DART SERVICE BULLETIN SB10-4

AFFECTING D206-628-013/-014 HELI-ACCESS-STEP TAT CHG 005 OR EARLIER

REF FAA STC: SA00500SE REF TCCA STC: SH98-14 REF EASA STC EASA.IM.R.S.01339

FIGURE 1 D206-628-013 (SHOWN) / -014 (OPPOSITE) 206 A/B FLOAT STEP INSTALLATION

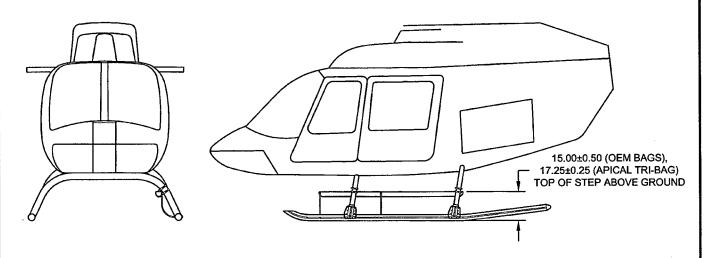
Unmodified D206-628-013/-014 Step Installations at change 005 (or earlier) will not install at the height required for compatibility with Apical Tri-bag Floats. D206-628-013/-014 steps installed with OEM floats (at 15.00" height) are unaffected.

For customers with D206-628-013/-014 Step Installations at change 005 (or earlier) and Apical Tri-Bag Floats, the step must be installed at least 17.00" high from the ground to prevent interference with the floats when they are deployed.

The DSI-9500-011 lug upgrade kit is available to update existing D206-628-013/-014 steps to change 006. The kit contains additional lugs that allow the step to be installed at 17.25" height. D206-628-013/-014 steps installed with OEM floats (at 15.00" height) do not require the kit.
